**MARICOPA COUNTY**  
*Department of Transportation*

**MEMORANDUM**

**Date:** January 8, 2016  
**To:** MAG Specifications and Details Committee  
**From:** Robert Herz, MCDOT Representative  
**Subject:** Miscellaneous Corrections **Case 16-01A**

**Date:** August 23, 2016  
**To:** MAG Specifications and Details Committee  
**From:** Robert Herz, MCDOT Representative  
**Subject:** Miscellaneous Corrections

**6' CHAIN LINK  
FENCE AND GATE**

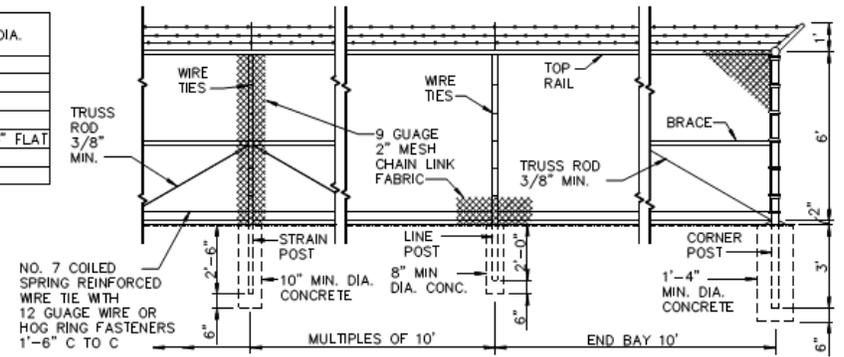
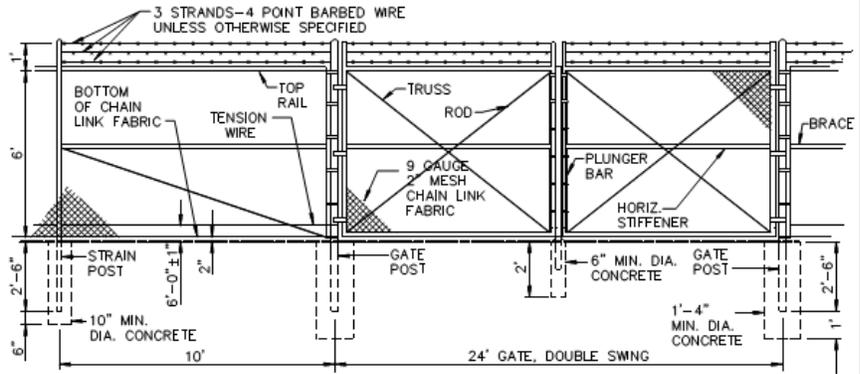
**PURPOSE:** Correct Chain Link Fence Post Discrepancy. The required diameter for a 6' chain link fence line post is 2" per Table 772-1 and 1.5" per Detail 160.

**REVISION:** Adjust Table 772-1 to match Detail 160. This will make MAG requirements match the size required by ADOT Drawing number C-12.20.
